**REPORT TO:** Committee of Adjustment

**REPORT NO.:** DSD-2025-282

**SUBJECT:** Minor Variance Application A2024-075 - 96 Wood Street

Figure 2: Site Plan - Revised May 2, 2025

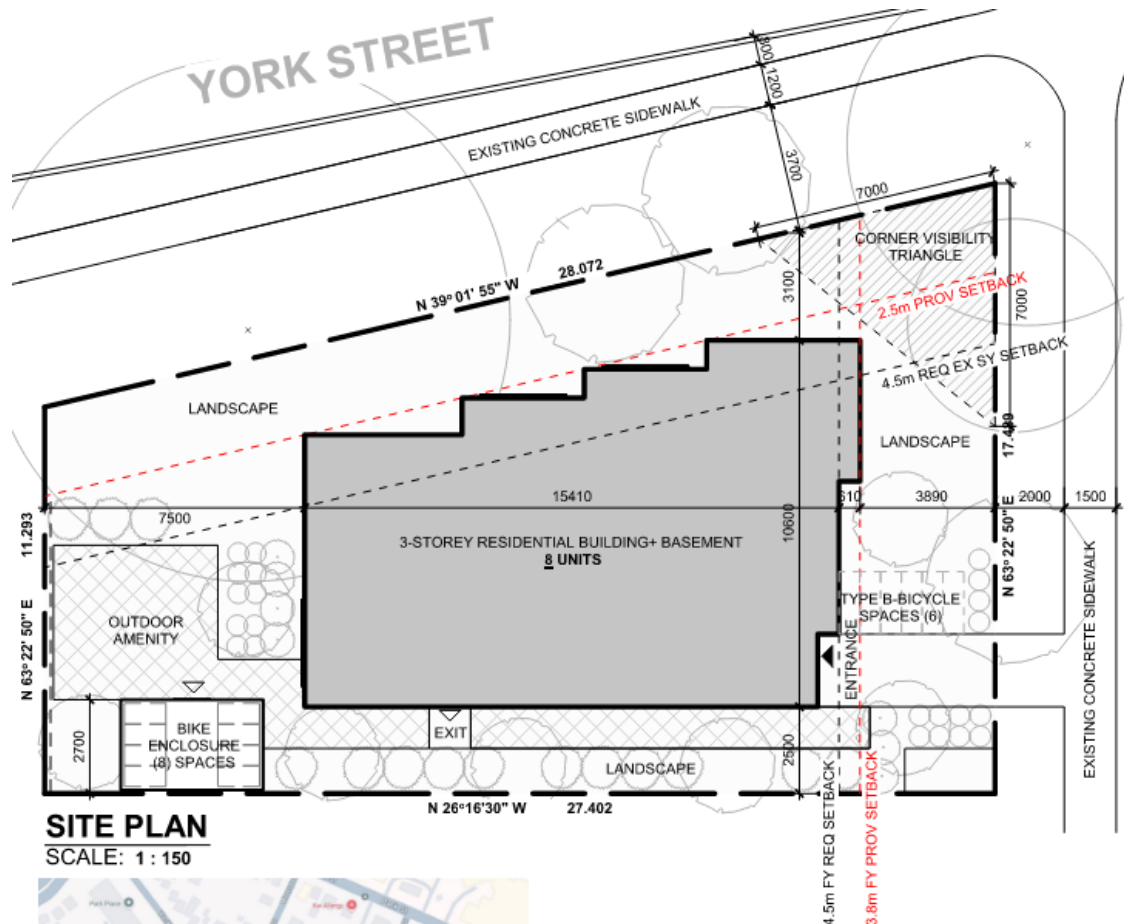
The Applicant provided revised documents on May 2, 2025, which states that the large tree on York Street would be preserved. The proposed new driveway and hard scaped amenity area within the tree's rootzone had been removed as shown on Figure 2. However, the building's location and extent of excavation had not changed as previously recommended. The revised Arborist Report claims that since the revised site plan allows for the rootzone to the north, west, and south to remain largely untouched, the tree should tolerate some encroachment into the rootzone due to foundation excavation. However, Forestry staff have significant concerns with this revised evaluation and lack of supporting evidence. The revised Arborist Report does not provide sufficient rationale to support this claim by analyzing the excavation required for the main building, other than stating that the other areas of untouched rootzone should be sufficient to preserve the tree. For example, the revised Arborist Report does not provide an analysis of low-impact exploratory root investigations, exact area of disturbance within the tree protection zone required for excavation, exact distance between the tree trunk and closest point of excavation, impacts to rooting areas outside the tree protection zone, or any pruning required for the new building. Without a comprehensive analysis of these factors, there is insufficient evidence to justify the conclusion that the tree will survive the negative impacts for the long term, particularly since the original Arborist Report clearly states this tree species is sensitive to root disturbance and will suffer negative impacts due to excavation within 2 metres of the

tree. As such, staff strongly disagree with the Arborist Report regarding this tree on York Street and anticipate the potential impacts from the proposed development will result in the tree's removal. Preservation of this tree for the long term is essential for adhering to the Official Plan and as such, staff must recommend refusal for the requested variance to permit reduced exterior side yard setback of 2.5 metres.

**Figure 4: Building Elevation (Wood Street Facade) - Revised May 2, 2025**

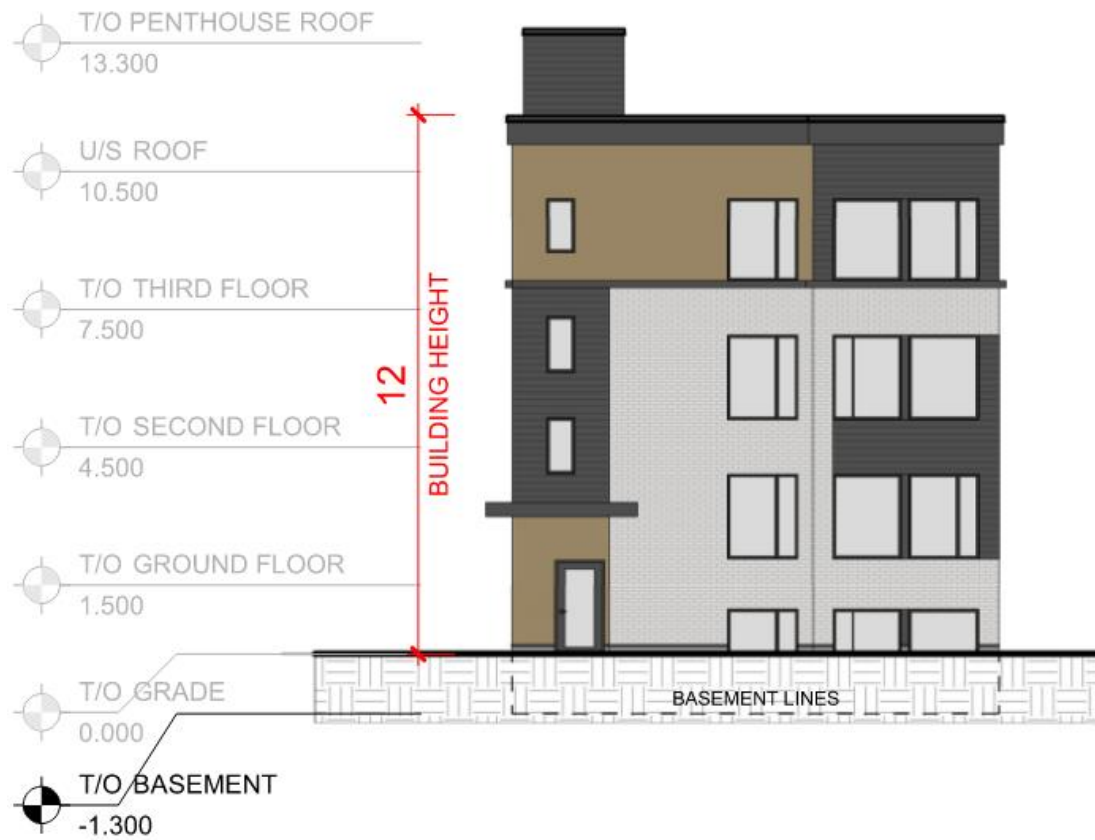
- The architectural design of the proposed building does not feature common housing design characteristics from the Gildner Green Neighbourhood CHL. In particular, the roof style is flat whereas most buildings feature a front gable or hipped roof and the materials are not identified on the building elevation drawings.
- The proposed development removes a mature tree on Wood Street and encroaches into the critical root zone of a mature City-owned tree on York Street, which Forestry staff anticipates will result in significant negative impacts that leads to the tree's untimely removal.

- The 3.5 storey and 12 metre building height of the proposed building does not align with the primarily 2 to 2.5 storey buildings in the Gildner Green Neighbourhood CHL. In particular, the adjacent building and surrounding buildings range from 1.5 to 2 storeys in height.
- The proposed lot coverage is inconsistent with other properties in the Gildner Green Neighbourhood CHL. In particular, the width and depth of the proposed building is larger than the adjacent and surrounding buildings.
- There is no consideration for the adaptive reuse of the existing building.

- The architectural design of the proposed building does not feature common housing design characteristics from the Gildner Green Neighbourhood CHL. In particular, (i) the roof style is flat whereas most buildings feature a front gable or hipped roof, and (ii) the materials are not identified on the building elevation drawings.

- The 3.5 storey height of the proposed building does not align with the primarily 2 to 2.5 storey buildings in the Gildner Green Neighbourhood CHL. In particular, the adjacent building and surrounding buildings range from 1.5 to 2 storeys in height.

**Figure 12: Tree Management Plan**

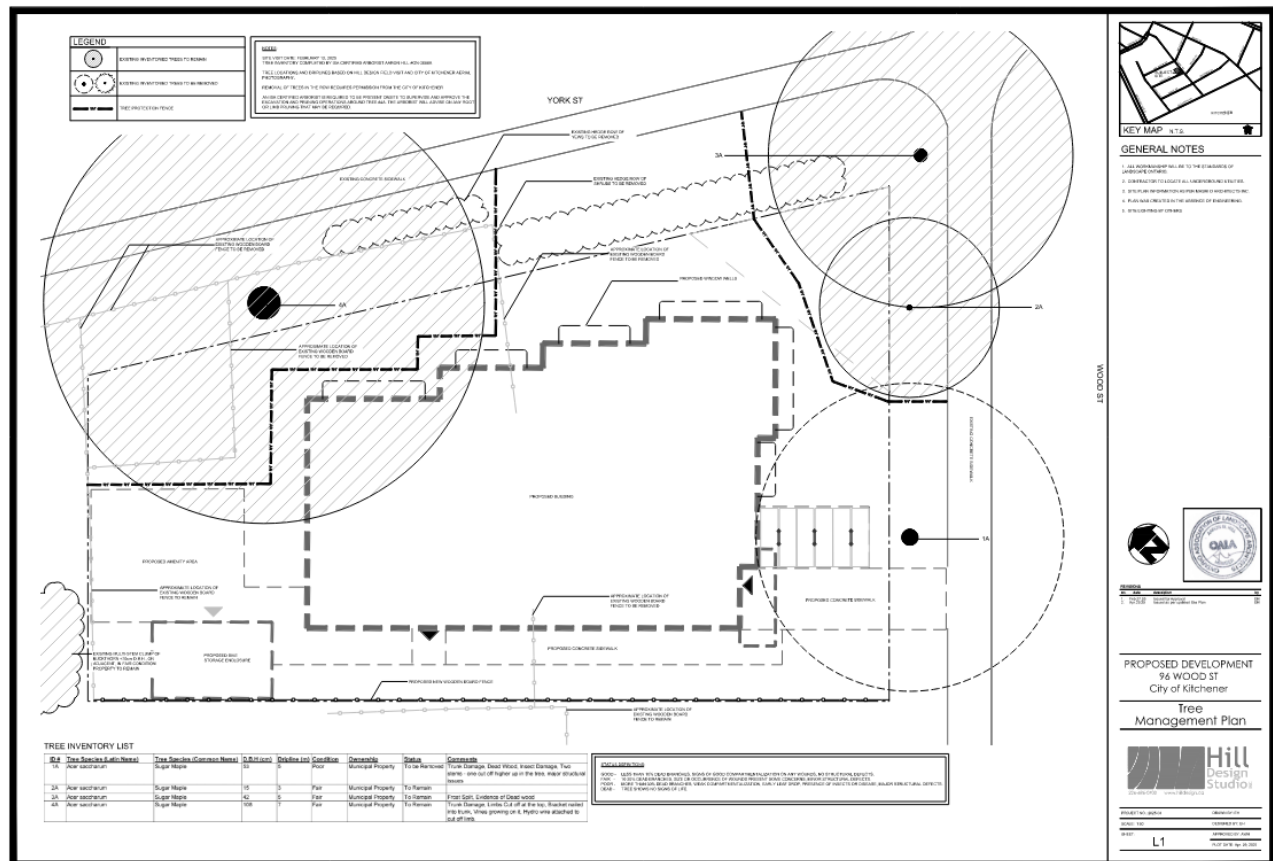
While staff agree with the Arborist evaluation for the tree on Wood Street, staff have significant concerns with the evaluation of potential impacts to the large Sugar Maple tree on York Street shown in Figure 8. The tree trunk is over 1 metre in diameter and requires a minimum setback (Tree Protection Zone (TPZ)) of 6.8 metres from all site alterations. The original Arborist Report prepared on February 27, 2025, states that this tree is in fair condition but is sensitive to root disturbance and is expected to decline in health due to the impacts of construction including hard surface elements that will require excavation and compaction within 2 metres of the tree trunk, well within the required setback. As such, the original Arborist Report recommend that the tree be removed. City Forestry, Planning, and Heritage staff will not support the removal of a large, healthy City tree that forms an essential component of the neighbourhood tree canopy coverage and streetscape character to accommodate a request for a reduced exterior side yard setback. As such, the Applicant was asked to revise their Tree Management Plan and Arborist Report. Staff

noted that the tree might tolerate a minor encroachment into the required TPZ, likely by maintaining the required 4.5 metre building setback. However, this minor encroachment must be justified by a fulsome analysis and supported by adequate tree protection measures to mitigate potential impacts.

- The tree has a DBH of 108cm, therefore its minimum setback (TPZ) is 6.8m.
- The proposed dwelling is located 3m from the trunk and further disturbance, including excavation for the foundation, extends as close as 1.75m from the trunk. The proposed extent of injury is substantial and exceeds the tree's expected tolerance level, thus necessitating removal. Forestry does not support removal of this tree.
- If clearance pruning is needed, the arborist report and TMP must clearly specify the extent of pruning.
